The National Construction Code Volume One

Design Development Report

Child & Adolescent Mental Health Services

Nepean Hospital

Figure No. 2– Smoke compartment exceeds 500m<sup>2</sup>

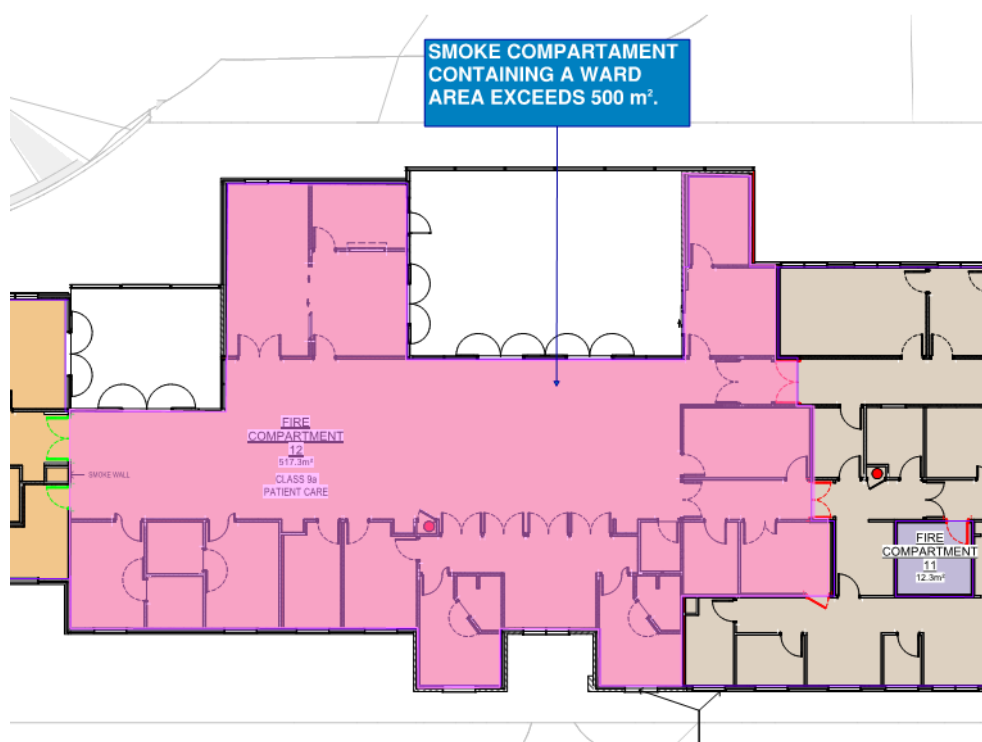
The size of the smoke compartment is proposed to be assessed as part of a Fire Engineering Performance Solution to be prepared by WSP in order demonstrate compliance with the nominated Performance Requirements of the BCA.

Figure No. 3 – Proposed separation of the Class 3 overnight accommodation area from the remainder of Level 01

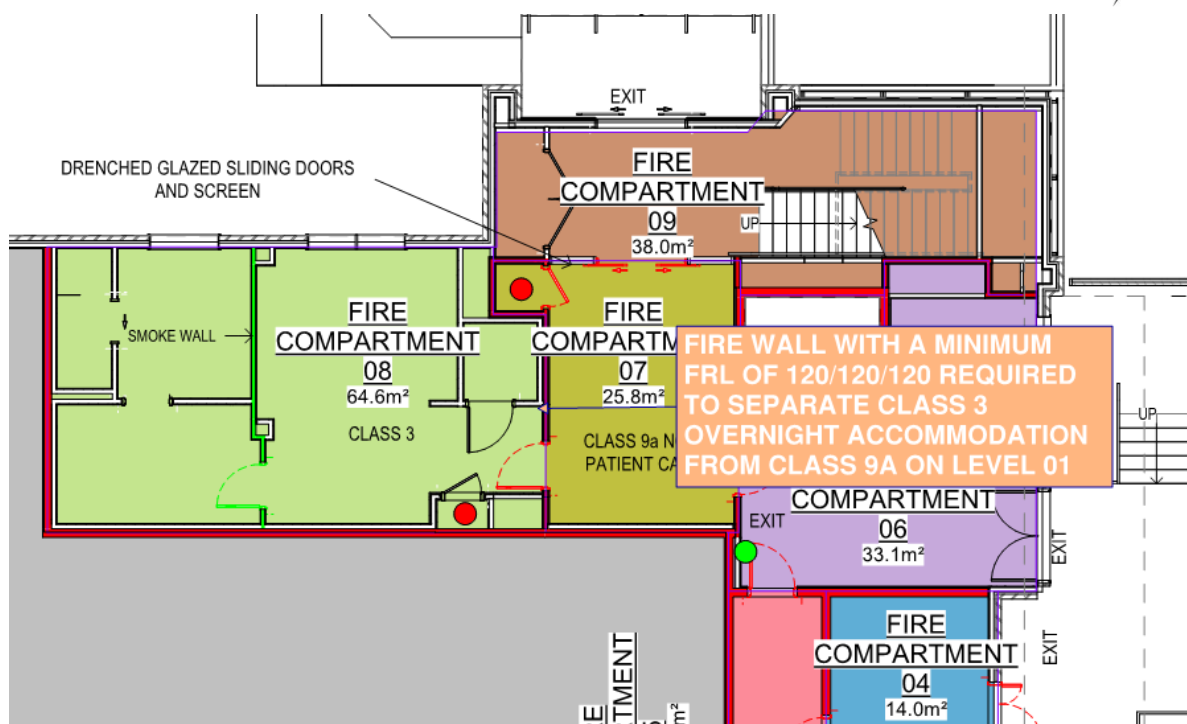
The fire wall separating the Class 3 area from the Class 9a area on Level 01 is required to have an FRL of not less than 120/120/120 in both directions.

Figure No. 4 – Required separation of Main Switch Room on Level 01

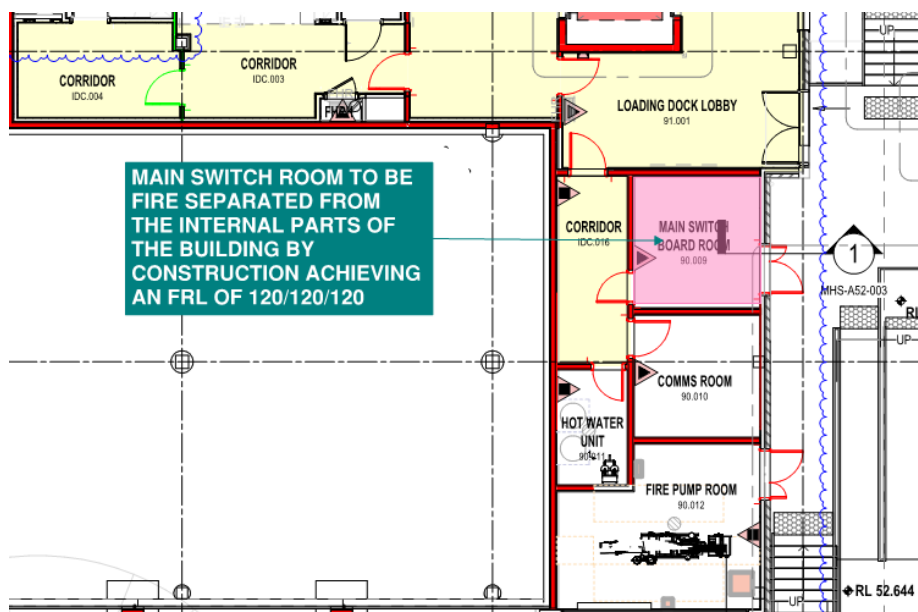
Any plantrooms housing switchboards for smoke control equipment will be required to be fire separated from the remainder of the building by construction achieving a minimum FRL of 120 mins.

Figure No. 6 – Locations of exposure of external walls of different fire compartments on Level 02

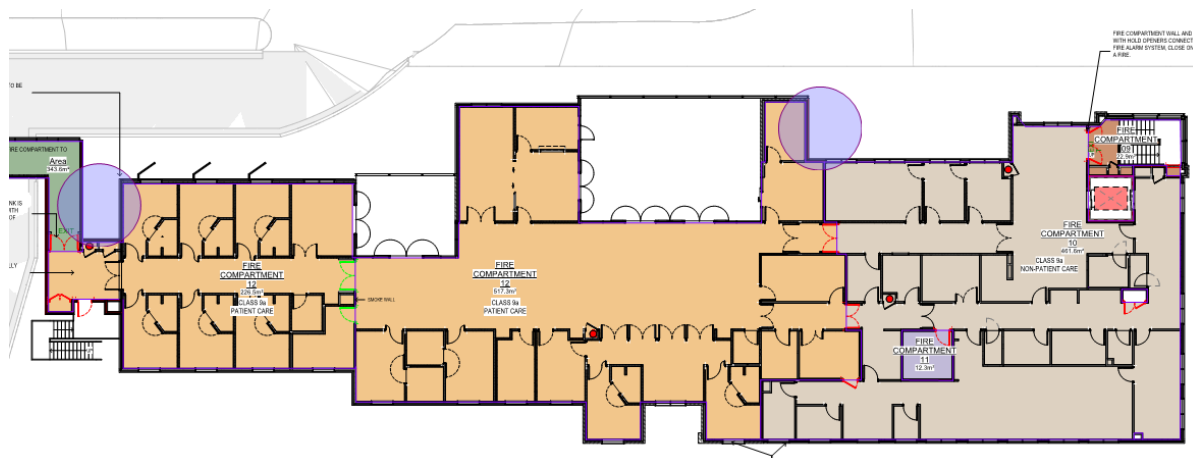
It is proposed to select the external wall of one of the fire compartments where exposure occurs and protect that wall in both directions, and such provide a comparative design to the DtS Provisions of the BCA which require both walls to be rated in one direction.

Figure No. 7 – Glazed sliding doors leading from the lobby space to the fire isolated (separated) stairway on Level 01 of the building

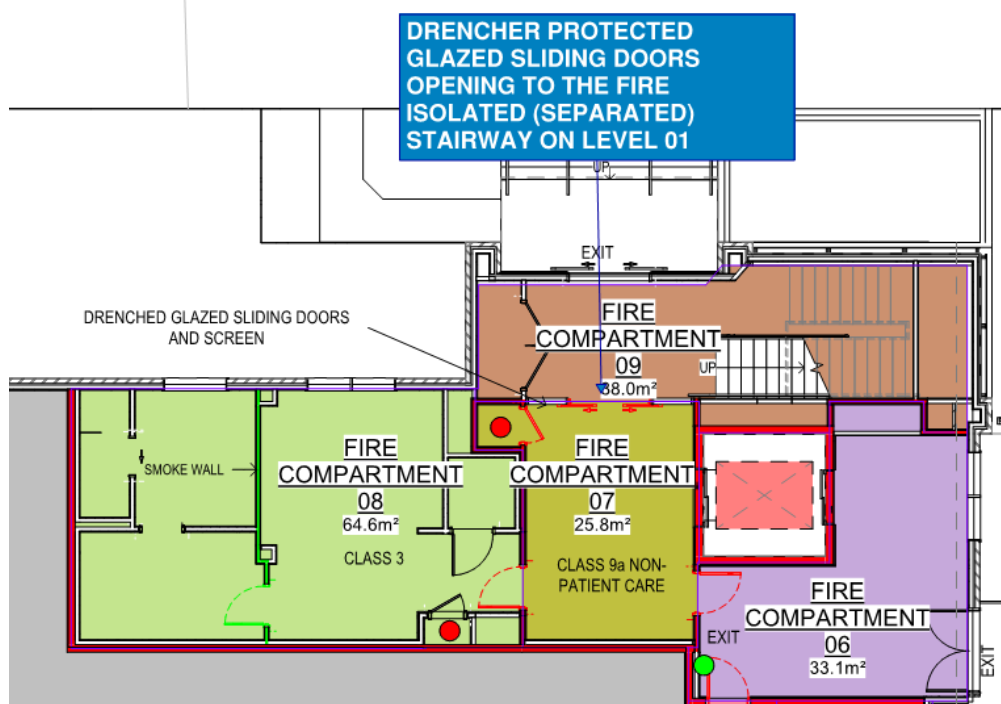
The provision of drencher protected glazing will be required to be assessed as part of the Fire Engineering Assessment to be undertaken by Arup to demonstrate compliance with the nominated Performance Requirements of the BCA.

Figure No. 8 – Riser shafts to be fire separated from the fire isolated stairway

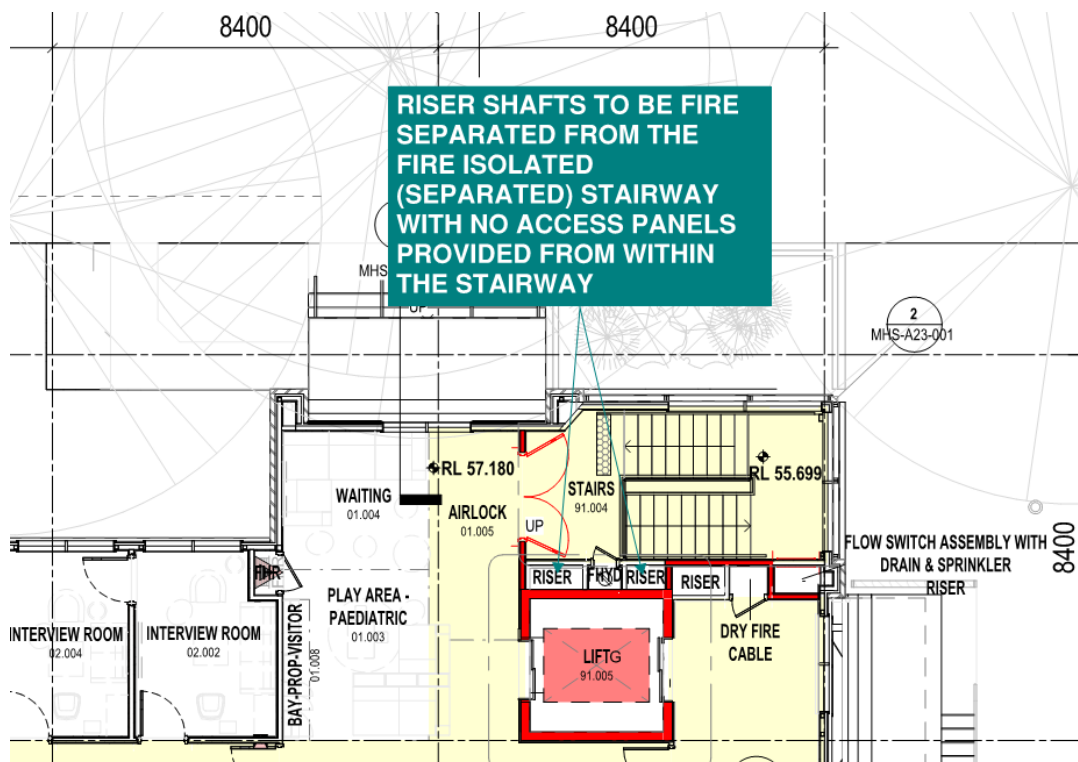
The Riser shafts currently documented within the fire isolated (separated) stairway to be fire separated from the stairway (with no access panels provided) by construction which achieves a minimum FRL of 120/90/90 (load-bearing) or -/90/90 (non-loadbearing).

Figure No. 9 – Proposed smoke separation of the Carer Bedroom from the adjoining Lounge area on Level 01.

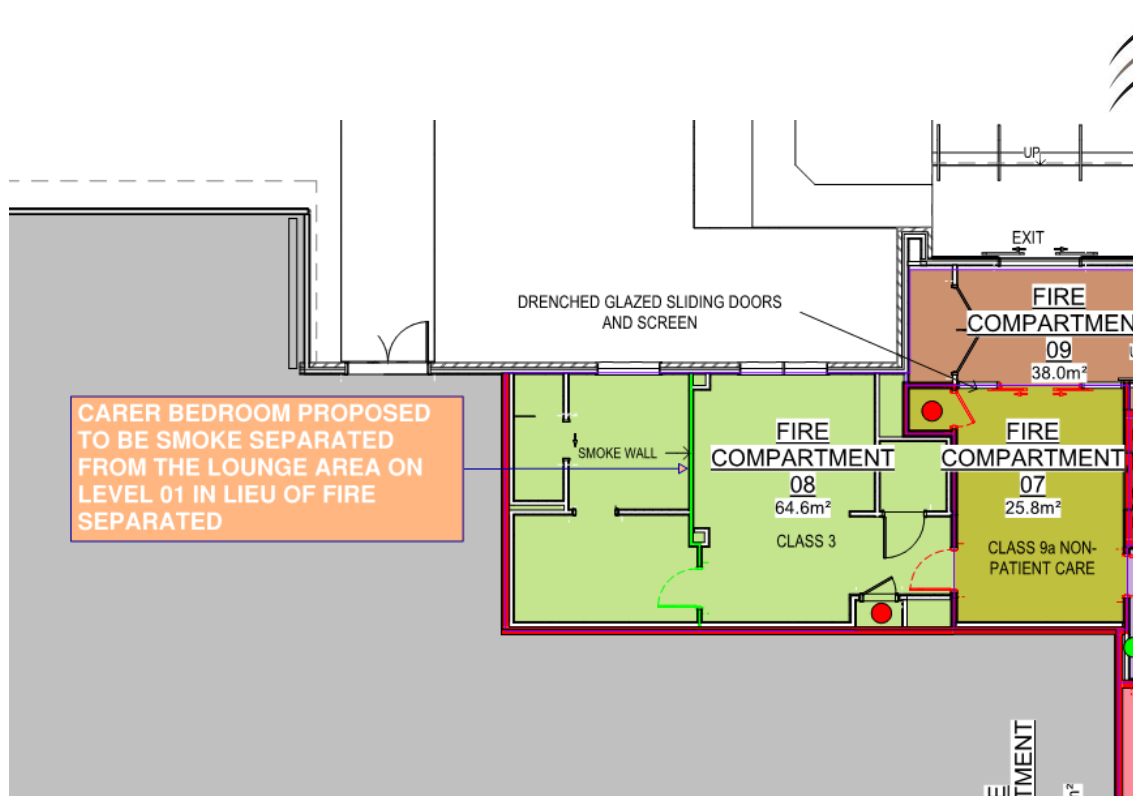
The Carer Bedroom is proposed to be smoke separated only from the adjoining Lounge Area on Level 01. The smoke separation of the bedroom from the lounge area is proposed to be assessed as part of a Fire Engineering Assessment to be undertaken by Arup in order to demonstrate compliance with the nominated Performance Requirements of the BCA.

Figure No. 10 – Doorways that are required to swing in both directions on Level 3

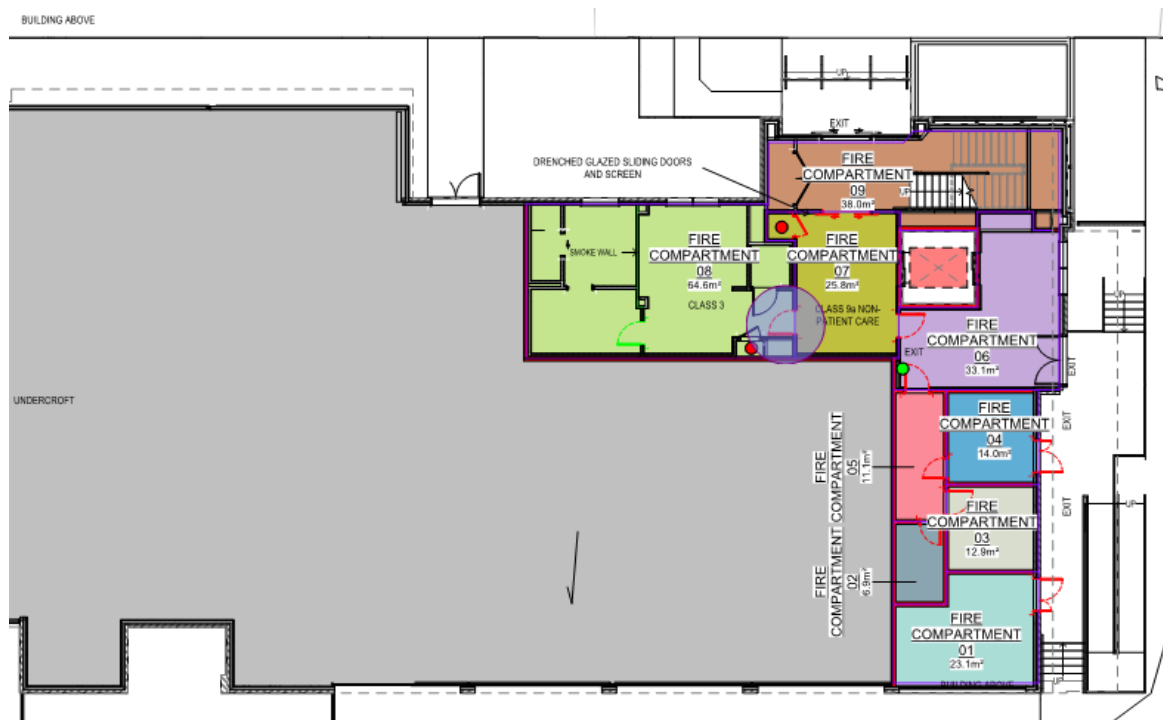
The doorways that swing in one direction only are proposed to be assessed as part of the Fire Engineering Assessment to be undertaken by Arup in order demonstrate compliance with the nominated Performance Requirements of the BCA.

Figure No. 14 – External pathway located within 6m of the external wall and openings to the Class 3 accommodation

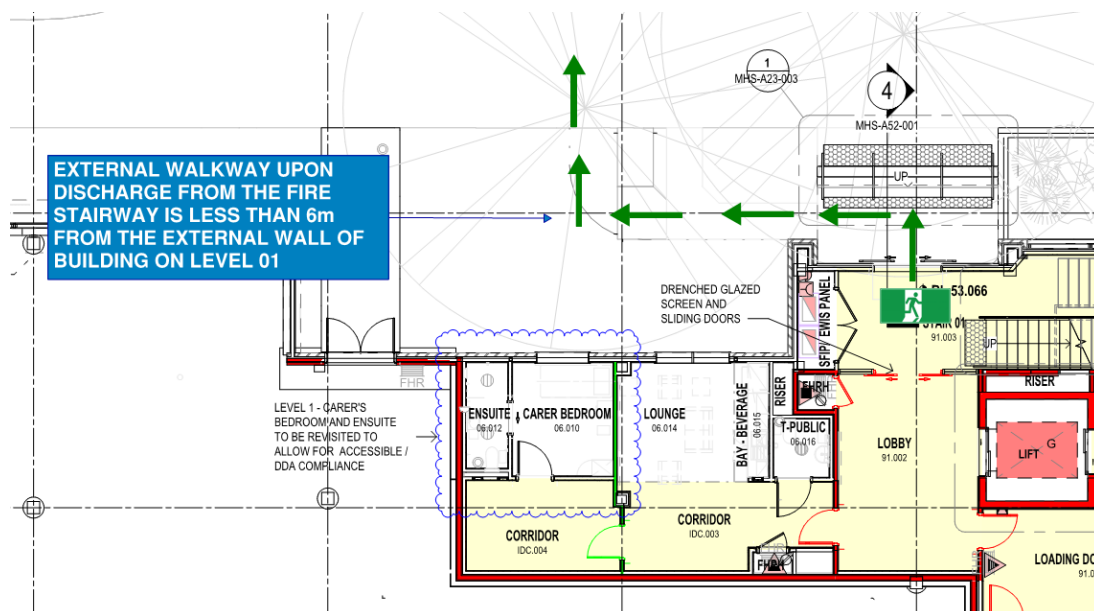
The path of external travel that an occupant is required to travel upon discharge from the fire isolated stairway is located less than 6m from the external wall of the building as detailed in the figure below.

Figure No. 16 – Required protection to the external stair provided in lieu of fire isolated stairway on Level 01

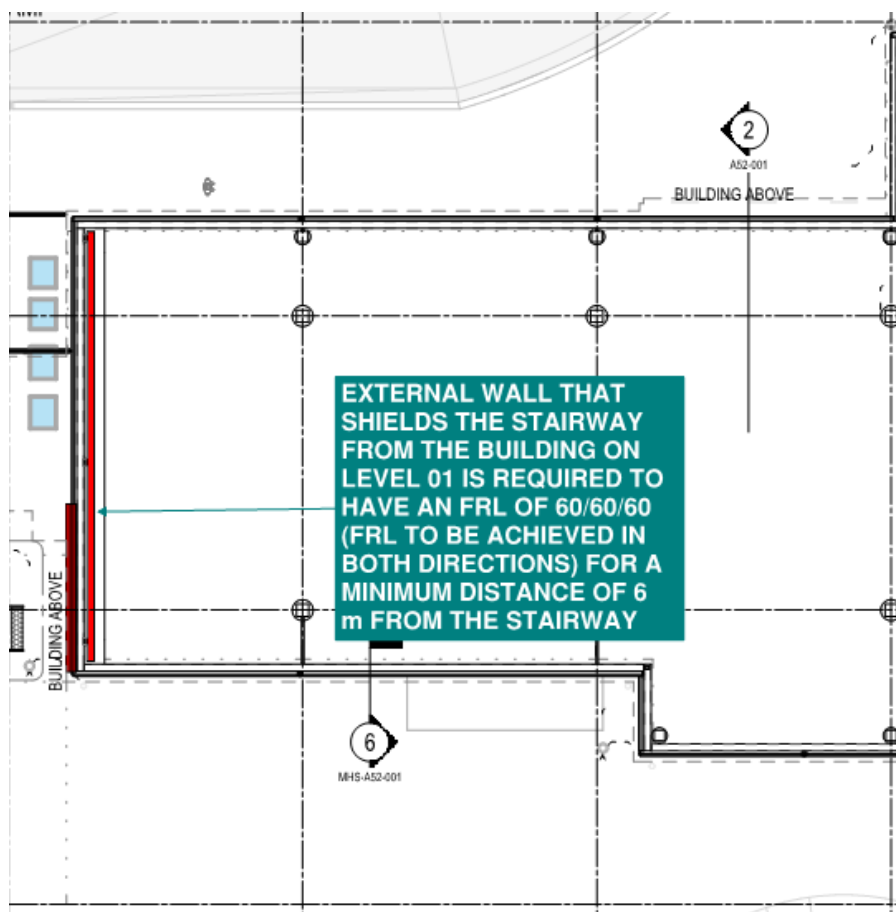
- + The stairway is to be constructed of materials that are non-combustible throughout.
- + The walls that separate the external stairway from the remainder of the building or alternatively shield it from openings in the external wall are required to have an FRL of 60/60/60 (achieved in both directions).
- + No openings are permitted to be located within 3 m of the external stairway unless shielded from the stairway by a wall with a minimum FRL of 60/60/60 or it is the doorway leading to the exit in which case it is required to be protected by a self-closing or automatic closing -/60/30 fire door.
- + Any openings located within 3m – 6m will be required to be protected in accordance with Part C3 of the BCA unless the external stairway is shielded by a fire rated wall.

Figure No. 18 – Space below fire isolated (separated) stairway cannot be used to form an enclosure or cupboard

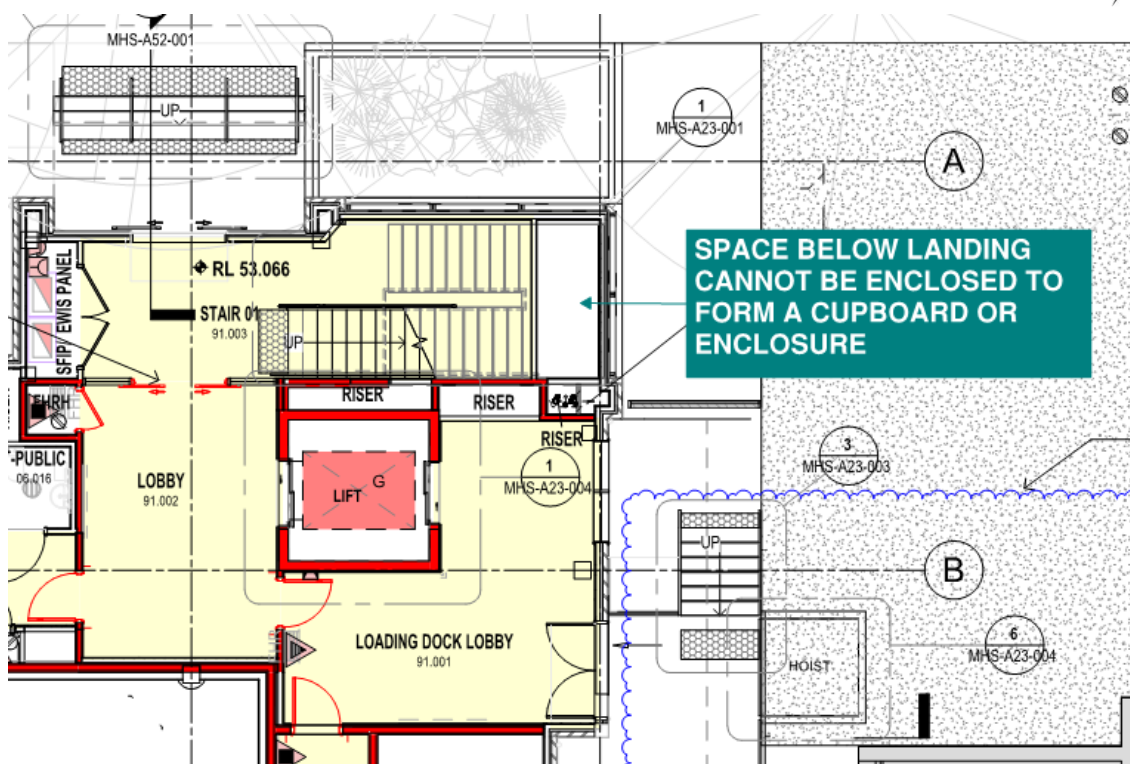
In this regard, the space below landing of the fire isolated (separated) stairway within the main entry and cannot be enclosed to form a cupboard or enclosure of any form.

Figure No. 25 – Glazed sliding door on Level 01 which leads to the fire isolated (separated) stairway

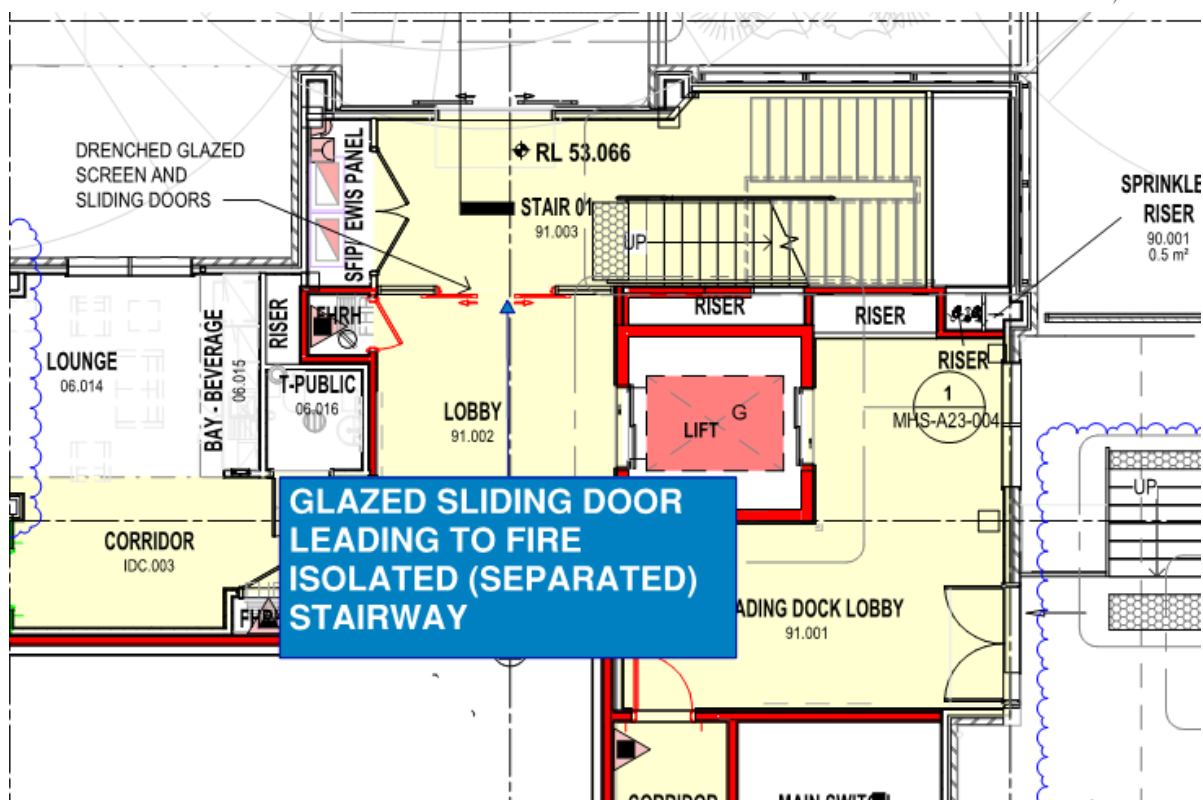
If any sliding door is proposed to be located within the patient care areas, it will be required to be assessed as part of the Fire Engineering Performance Solution to be undertaken by Arup in order to demonstrate compliance with the nominated Performance Requirements of the BCA.

Figure No. 26 – Horizontal exit that swings against the direction of egress on Level 01

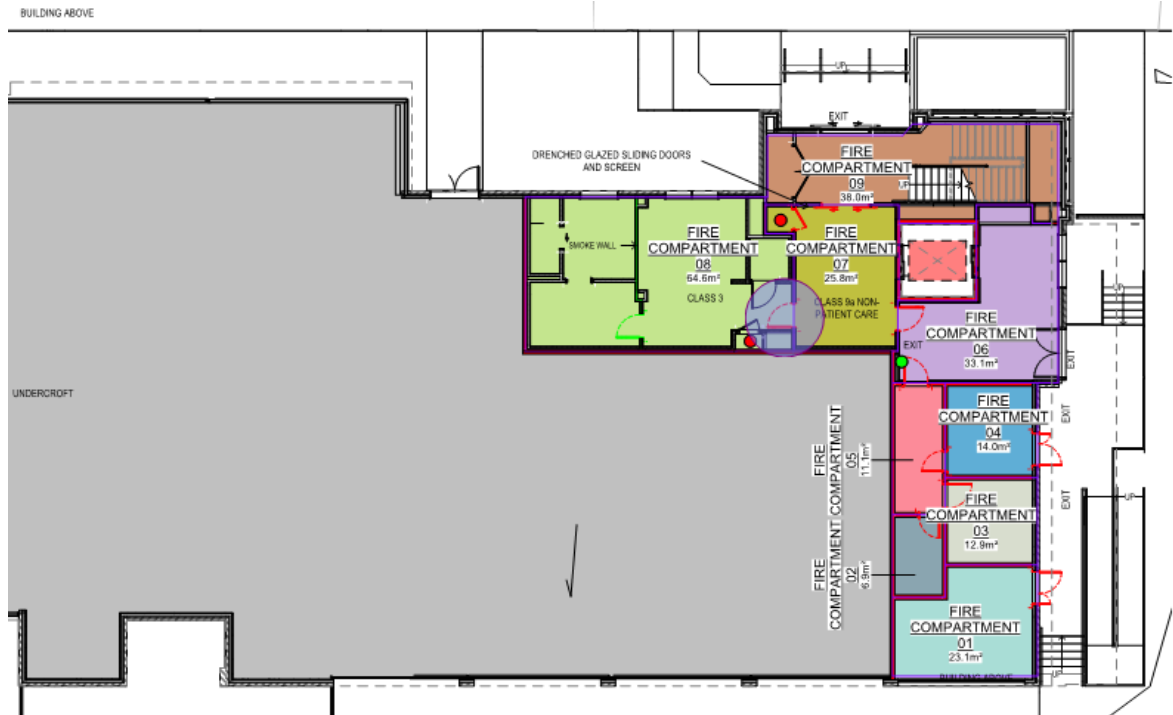
The swing of the horizontal exit doors against the direction of egress is proposed to be assessed as part of the Fire Engineering Assessment to be undertaken by Arup in order to demonstrate compliance with the nominated Performance Requirements of the BCA.
